Roop Street Widening – Phase II Project
Labor Commissioner PWP#CC-2010-118
Public Works Project No. 3.0302
Engineer's Estimate: \$4,400,000

January 22, 2010

Addendum No. 1

R9:

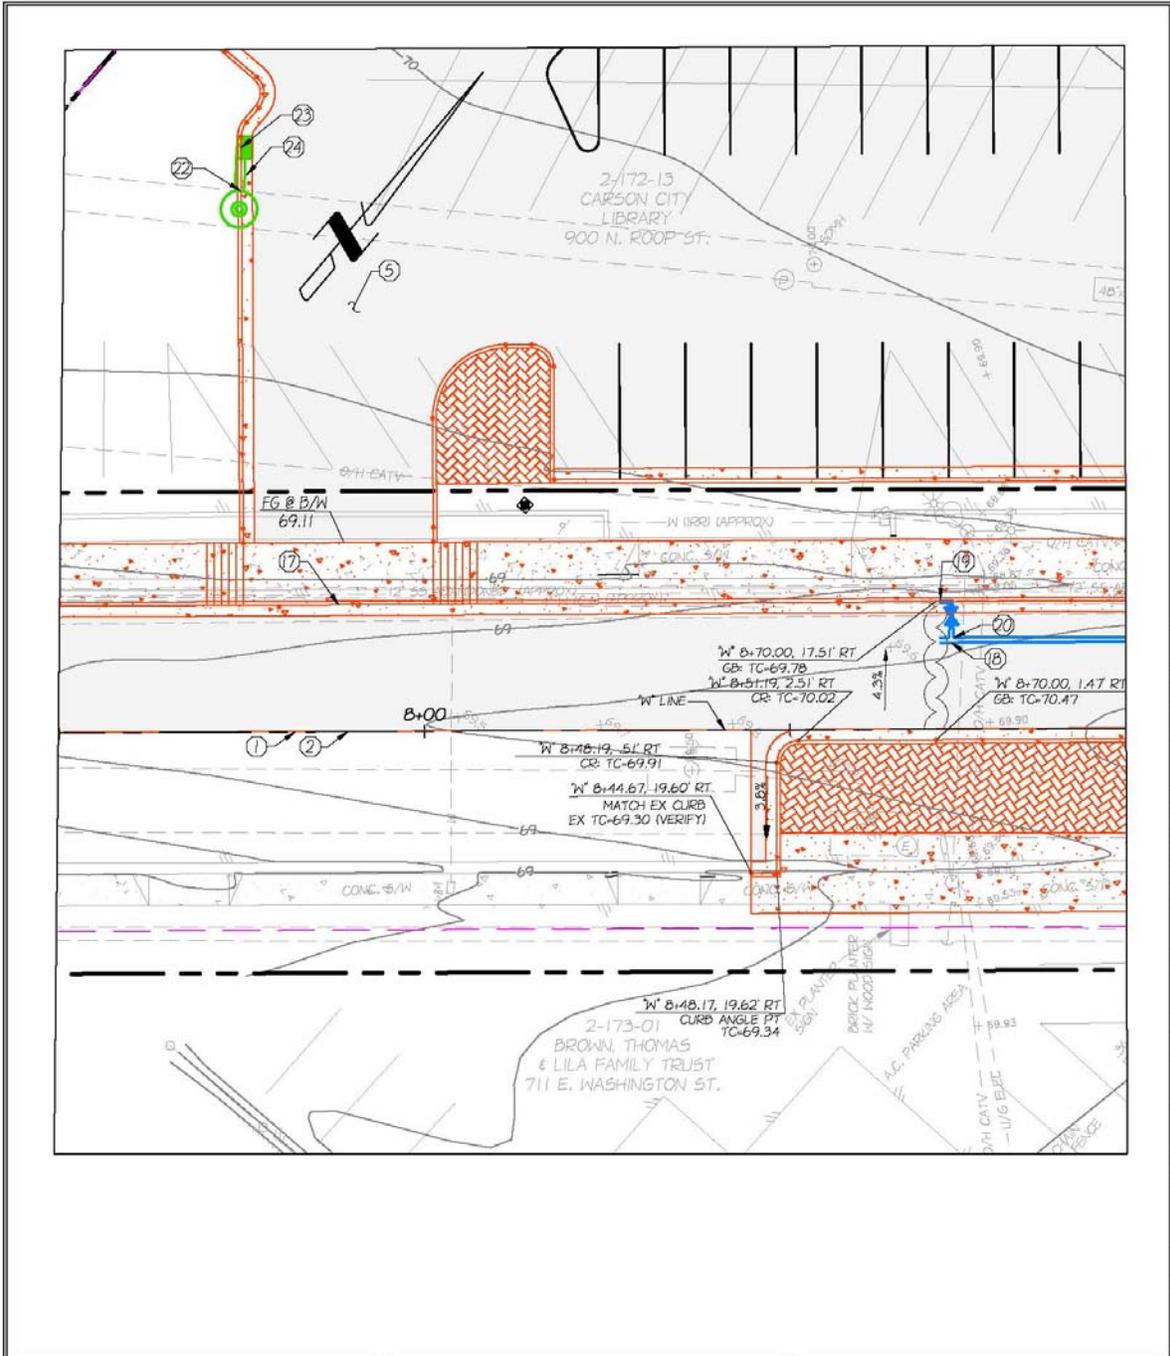
Add hatch to indicate decorative stamped concrete to the island at the library entrance as shown is the display below:

R20:

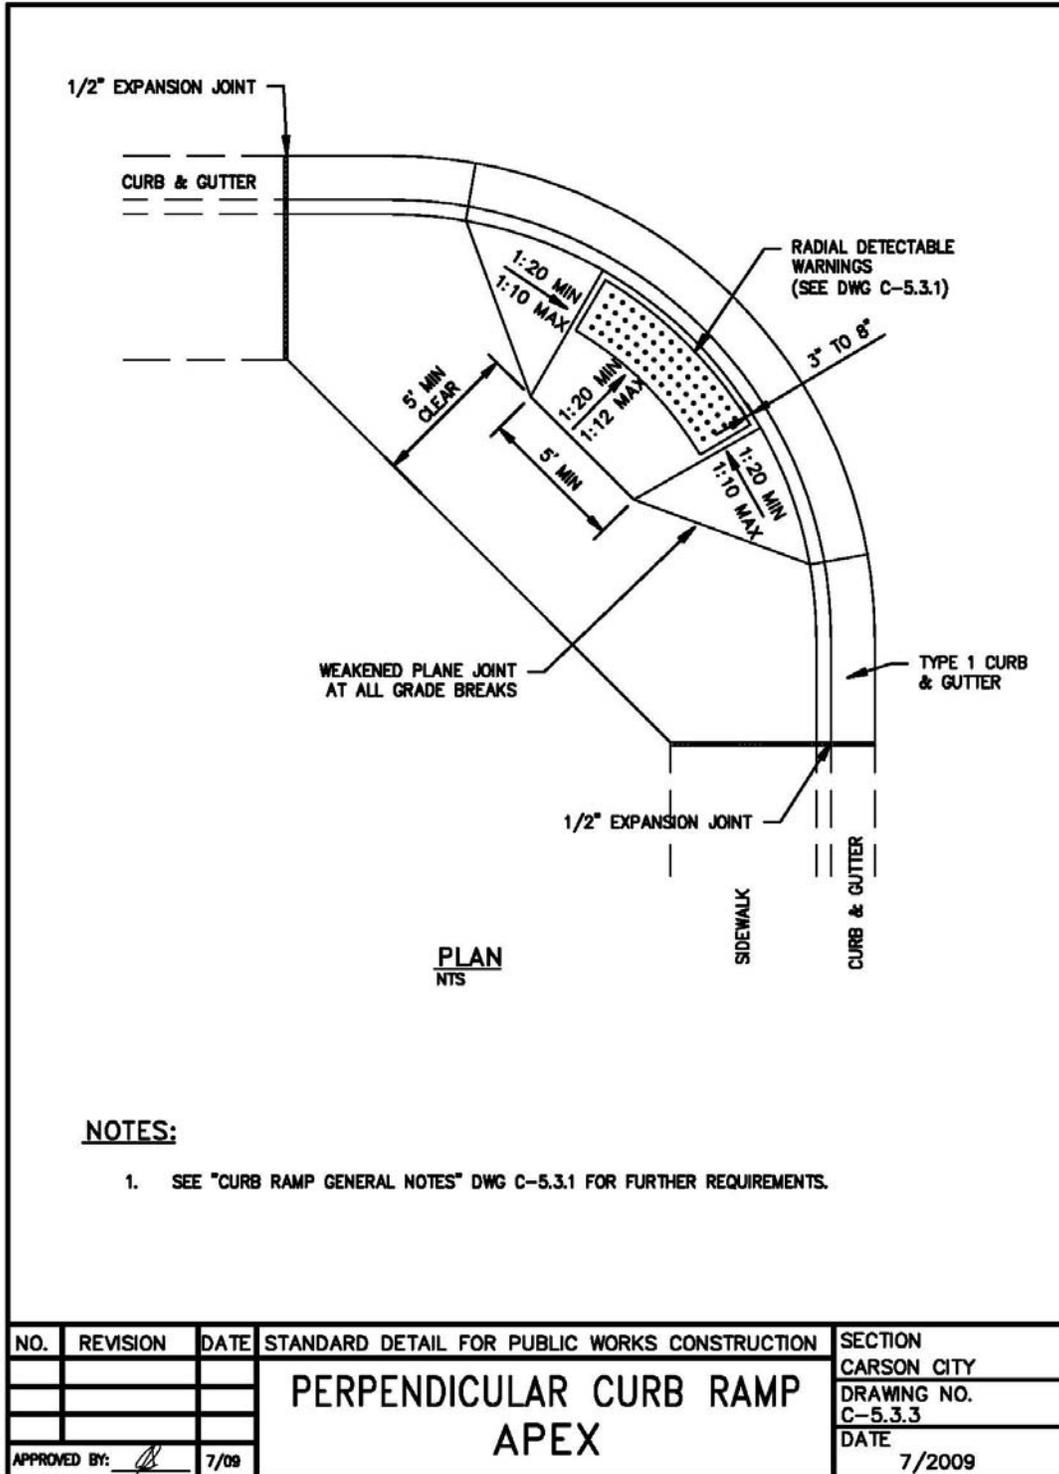
Add the following note to landscape area at the corner of Beverly Drive and
Roop;
